**Francesco Dottori (Referee)**

The manuscript describes the application of three different modelling approaches to map flash flood hazard in three case studies in South France. The topic is undoubtedly worth of interest, considering the potential for near-real-time applications and the possibility to include flash flood impacts in future applications. The manuscript is well structured and reasonably well written. The authors perform a detailed analysis of the model results, including the main types of error found, and this gives the reader a comprehensive overview of the strengths and limitations of each method. In my opinion, the paper will be ready for publications after a moderate revision to correct a few issues.

**Paul Bates (Referee)**

Figure 1. Comparison of high water marks elevation differences and river reaches averaged slopes (maximum value, 90% and 50% quantiles): a) Aude case study, b) Argens case study, c) Alpes Maritimes case study.

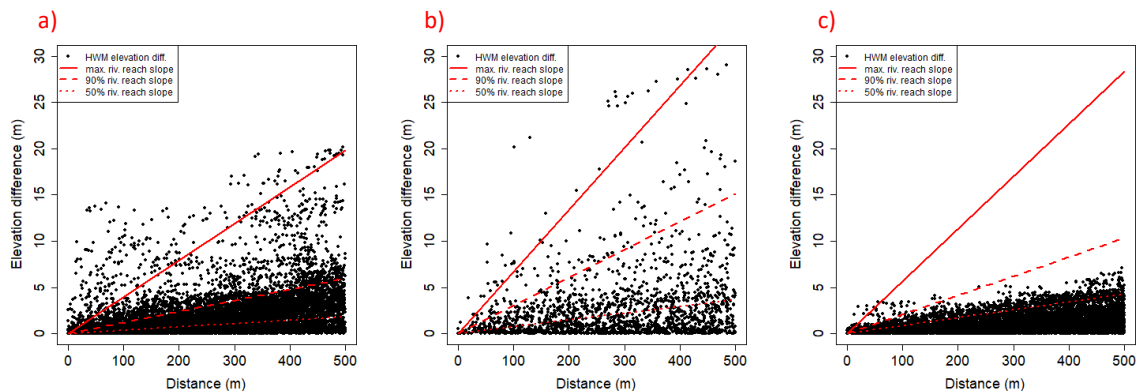
9. Section 3.1. This section needs to include a more extensive discussion of the uncertainties in the observed data. This then needs to be picked up in the discussion to determine whether the models can match the observed data to within error or not. You already discuss the terrain data error in the paper, but don't really say much about errors in the observed discharge other than the rainfall-runoff model generally matched the observed discharge to within 10%. However, discharge gauging during extreme floods is fraught with difficulty and you need to consider the likely error in this, even if this can only be a best estimate made with reference to other studies. The error in the rainfall-runoff model is somewhat misleading, as most such models usually have enough degrees of freedom to be able to match 'observed' data adequately, even if it has error and is disinformative. I would expect discharge gauging during flash floods to be have errors of at least  $\pm 20\%$ . Similarly, you need to say a lot more about how the high water marks were collected, what their likely error are and what QA/QC procedures you undertook to clean up these data. I think for each catchment you should include a plot of HWMs versus thalweg distance and also plot on this the overall valley slope derived from LiDAR data. This will show if there are obvious outliers as we would expect flood water surface profiles to decrease slowly and monotonically in a downstream direction. Regions of supercritical flow may be an exception to this rule of thumb, but, in general, this is the pattern we might expect. Plotting the model water surface slopes on these graphs would also be very informative. A further quality check is to plot the difference in elevation between pairs of high water marks and compare this to the valley slope. Figure 3 in this paper might be a useful template: Fewtrell, T.J., Neal, J.C., Bates, P.D. and Harrison, P.J. (2011). Geometric and structural river channel complexity and the prediction of urban inundation. *Hydrological Processes*, 25, 3173-3186. (10.1002/hyp.8035). Lastly, you need to say a lot more about how the inundation extent was mapped and what were the likely errors in this.

14. Section 4: Through this section and the discussion you need to take into account the impact of the observed data errors on your ability to make inferences and discriminate between the three models. Where do the models match the data to within error and where do they not?

The HWM data was extracted from the french national HWM database (<https://www.reperesdecruces.developpement-durable.gouv.fr>). This data is systematically checked before incorporation in the database. Presenting longitudinal profiles for our case studies is difficult because of the length and large ramifications of the considered river networks. Additionally, significant contrasts are locally observed between the HWM reported in the floodplain and the HWM in the main stream at a given location (presence of weirs, waterfalls, ..). The association of HWM to a talweg longitudinal distance may therefore raise some interpretation difficulties. However the graphs proposed by Fewtrell et al. (2011) are easier to plot and are presented below (figure 1) for the 3 case studies. The averaged slopes of the river reaches where HWM are available are also plotted (maximum slope value, and 90% and 50% quantiles for each case study). According to these figures, some HWM elevation differences may indeed appear as outliers since exceeding the maximum slope of river reaches. But this is observed only for a limited number of HWM couples (3% for the Aude, 2% for the Argens, and less than 1% for the Alpes Maritimes case study). And these large elevation differences cannot be systematically attributed to errors in the data, but also to local phenomena such as bridge blockages, presence of weirs or waterfalls. Considering the limited number of HWMs concerned we think that the possible presence of errors does not significantly affect our comparison results.

We therefore chose to mention clearly the origin of the data in section 3.1 and the possible presence of remaining errors in the HWM data: “The HWM data was extracted from the french national HWM database (<https://www.reperesdecruces.developpement-durable.gouv.fr>). This data is systematically checked before incorporation in the database and therefore should not include large errors. However, errors up to 50 cm should be considered as common considering the accuracy of topographic surveys (HWM location and elevation), and/or possible inappropriate choice of HWMs locations (increase of water surface elevation in front of obstacles, capillary rise of moisture in walls, ..). Some larger errors may also remain for a very limited number of HWMs, and may result locally in large estimated simulation errors. But all these error sources are common to the 3 methods and should not affect the comparison results.”
